### ADDENDUM

**Addendum No.: 2**

**Renovations at Calkins Park**

**ADDENDUM NO. 2**

SHEET NO.  
**SK1**

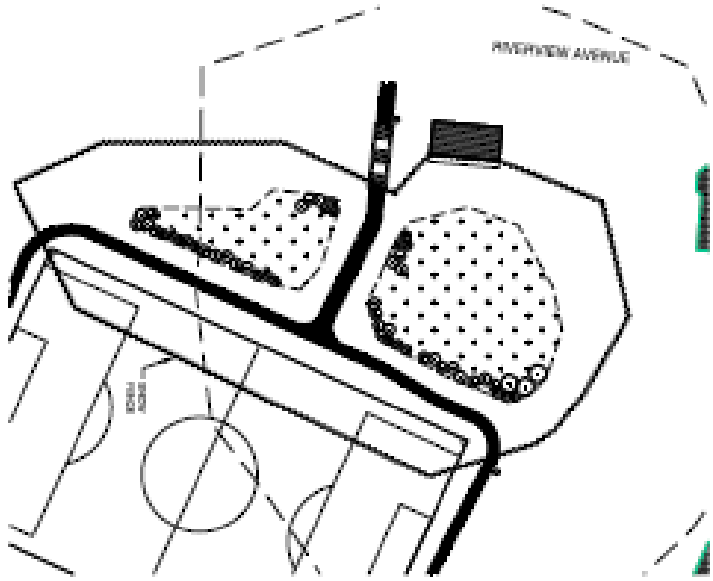
2. Bituminous concrete (asphalt) pavement shall be installed under both bleachers. Refer to detail 1/L-4.0
3. Refer to Sheet SK-1 attached for delineation of porous bituminous concrete pavement – Add Alternate No. 2.

SHEET NO.  
**SK2**

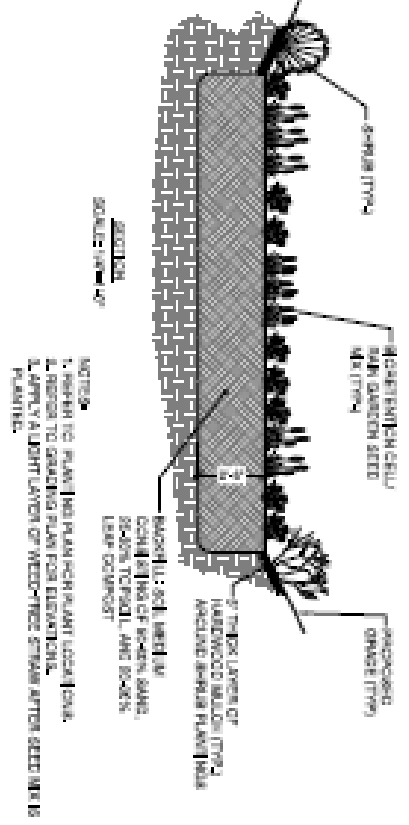
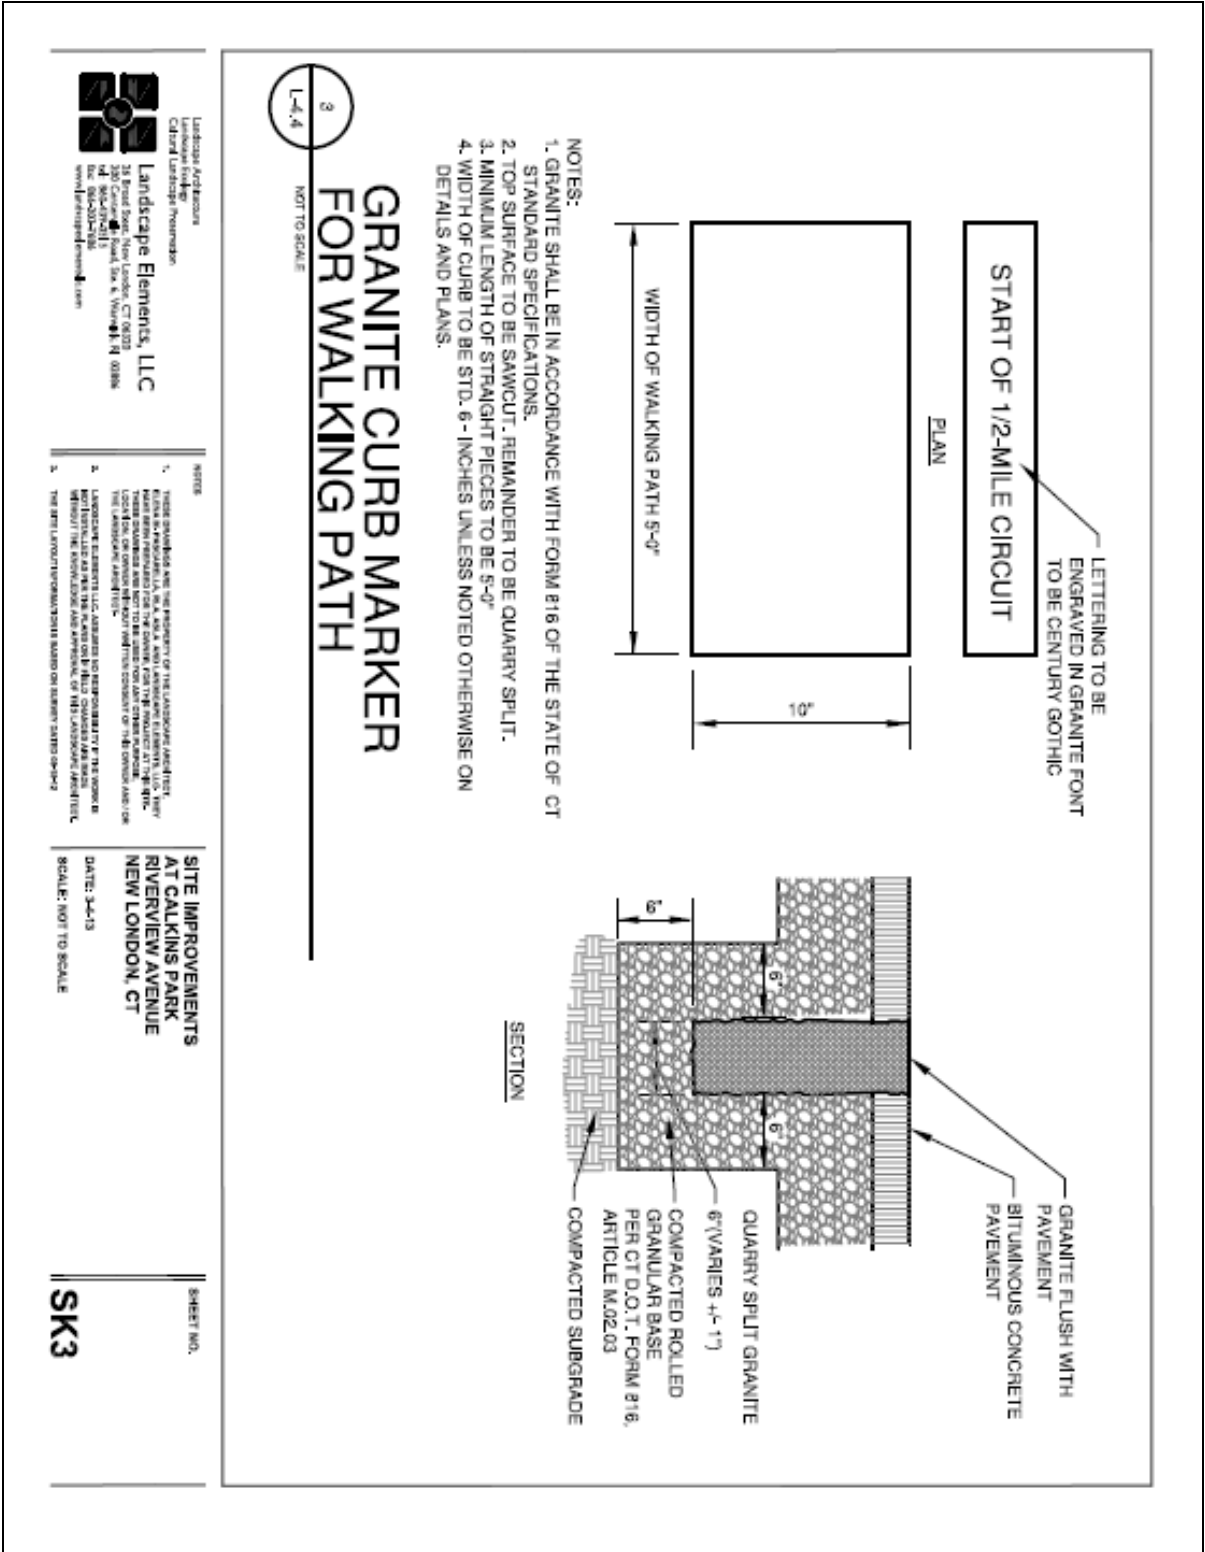
10. For changes to SITE PREPARATION METHODS AT WETLAND AND DETAIL 1/L-4.1 refer to Sheet SK-2 attached.
11. For Detail 3/L-4.1: The soil mix for shrub plantings. in Note #1 shall read as follows: "Improved Soil Mix: Soil medium consisting 50-60 % sand, 20-30% topsoil, and 20-30% leaf compost." This mix is ONLY for shrub plantings in the bio-retention swale/rain garden areas.
